PIC32MX534/564/664/764 Family Silicon Errata and Data Sheet Clarification

The PIC32MX534/564/664/764 family devices that you have received conform functionally to the current Device Data Sheet (DS60001156H), except for the anomalies described in this document.

FIGURE 1: EXTERNAL COMPARATOR SCHEMATIC EXAMPLE

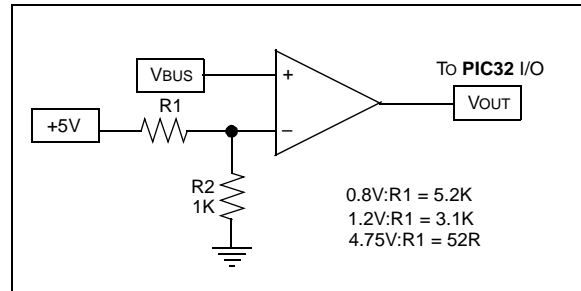
16. Module: USB

When the USB model is configured for OTG operation, it may not recognize all required OTG voltage levels on VBUS pin.

Work around

Use external comparator circuit to detect OTG specific voltage levels on VBUS pin.
